Re: S.A. Dunn Construction and Demolition Landfill and Mine
DEC No.4-3899-00006

CITY OF RENSSELAER
SUPPLEMENTAL COMMENTS ON S.A. DUNN
CONSTRUCTION AND DEMOLITION DEBRIS
LANDFILL AND MINE

**DUNN C&D LANDFILL
IMPACTS ASSESSMENT**

November 10, 2022

PHOTO 3

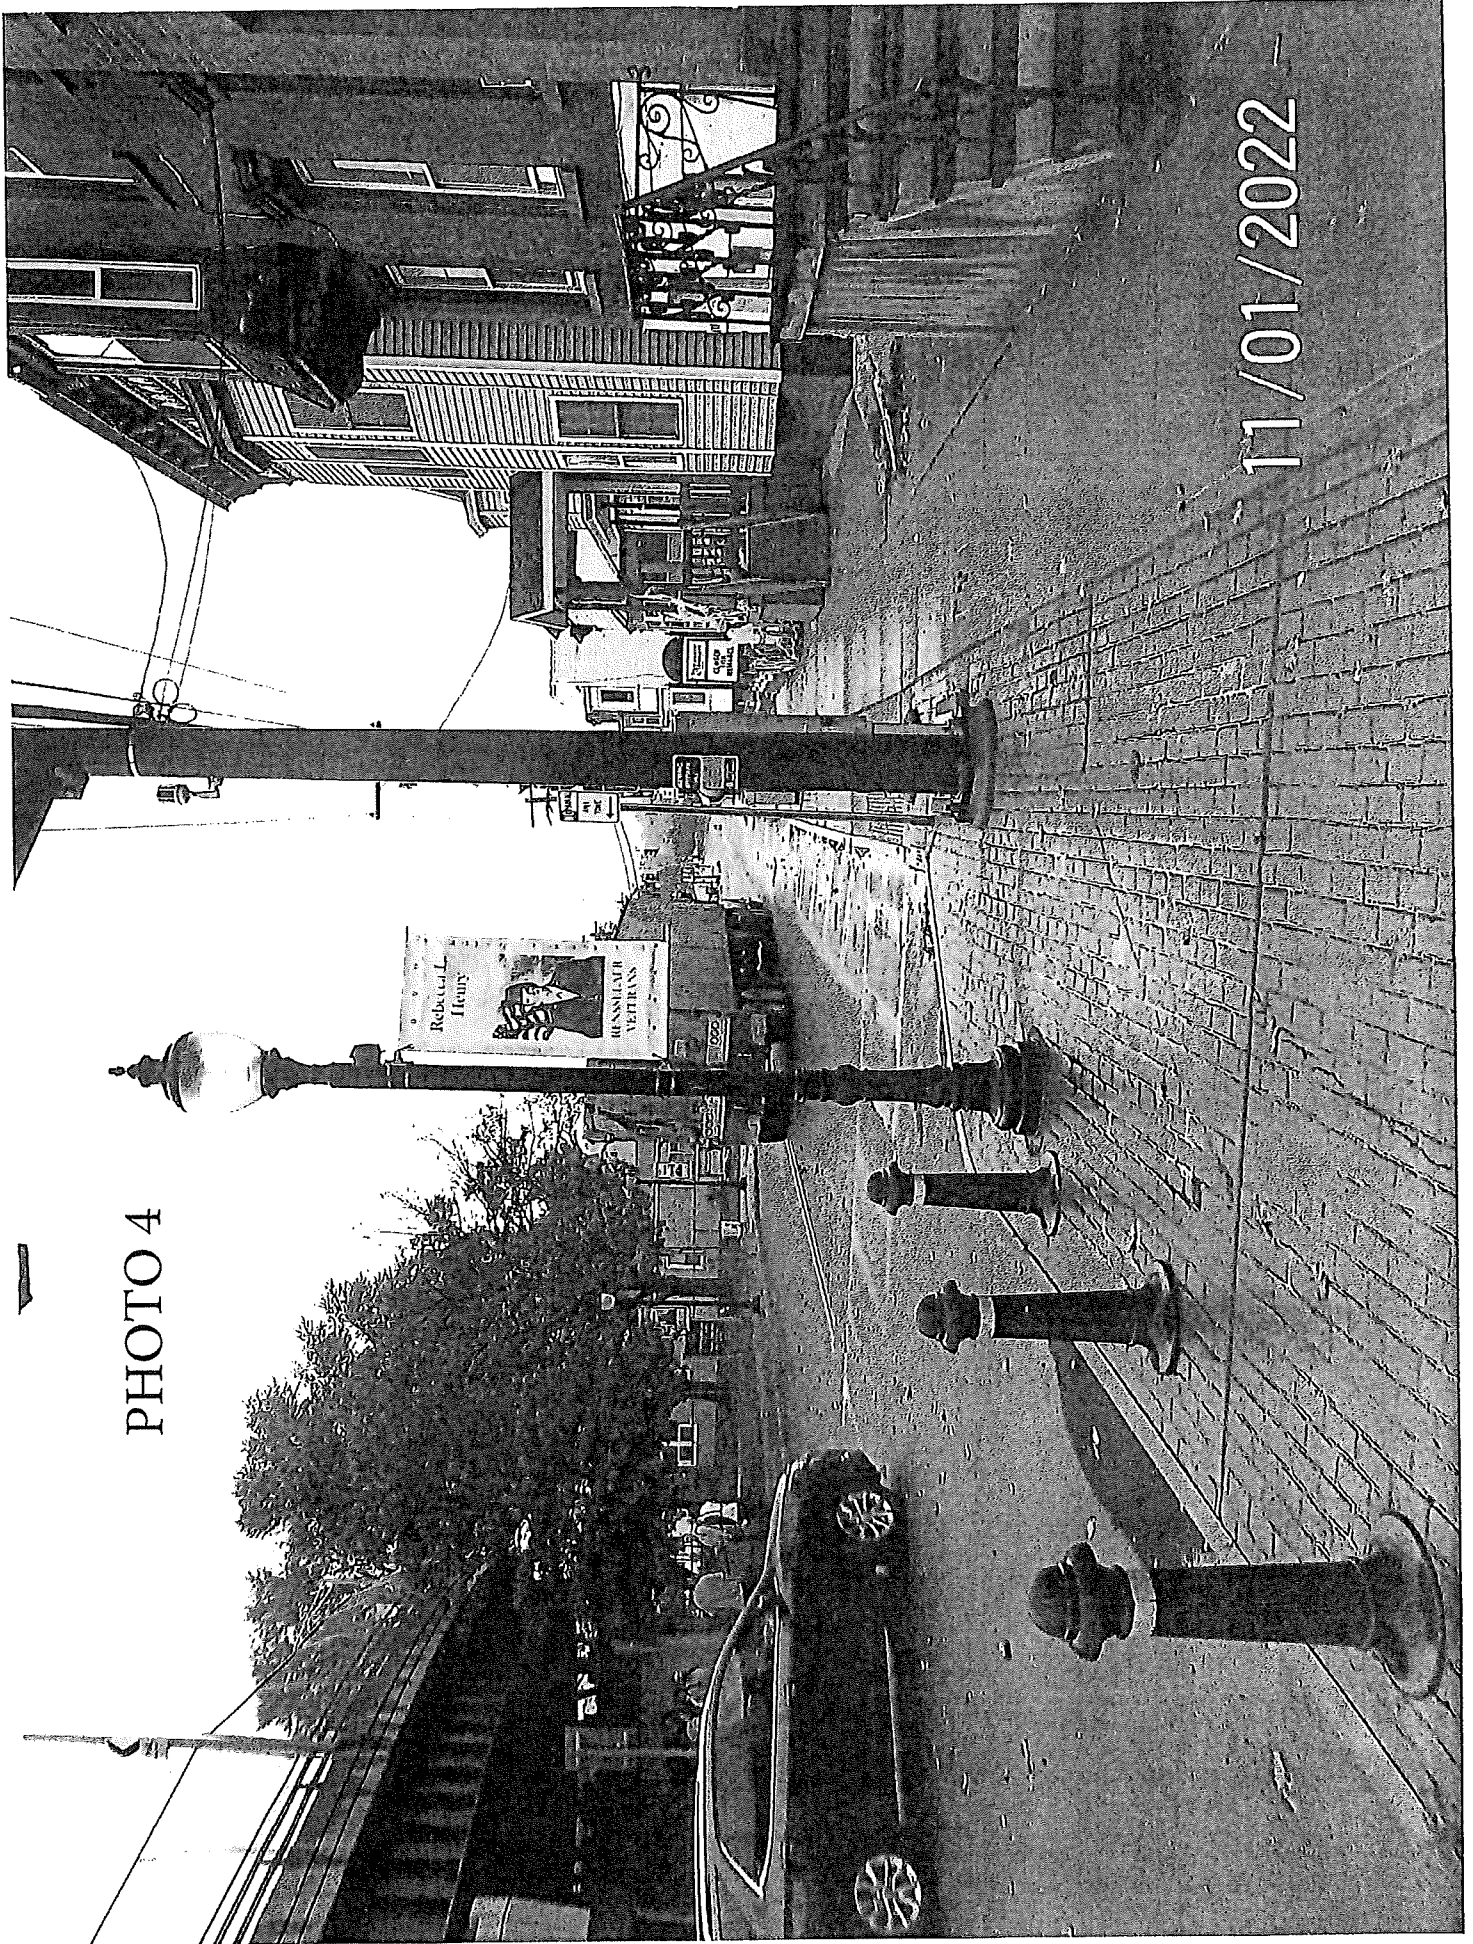
Of the four intersections observed this one operates the worse and presents the most safety concerns. Most of the tractor trailers observed exit down the ramp and move directly into the right turn lane, either partially or completely, to make the left turn (see photos 1-4). On some occasions it was observed that other traffic coming down the ramp and making left turns continues along beside the truck making a left turn which makes for a dangerous situation when both try to turn left at the same time. If the truck does stay in the left turn lane they need to move dramatically into the right turn lane when they start the turn (see photos 5-8). This endangers traffic legally in the right turn lane. It does not appear that any left turn movement can be made if they stay completely within the left turn lane. If they try they ride up onto the
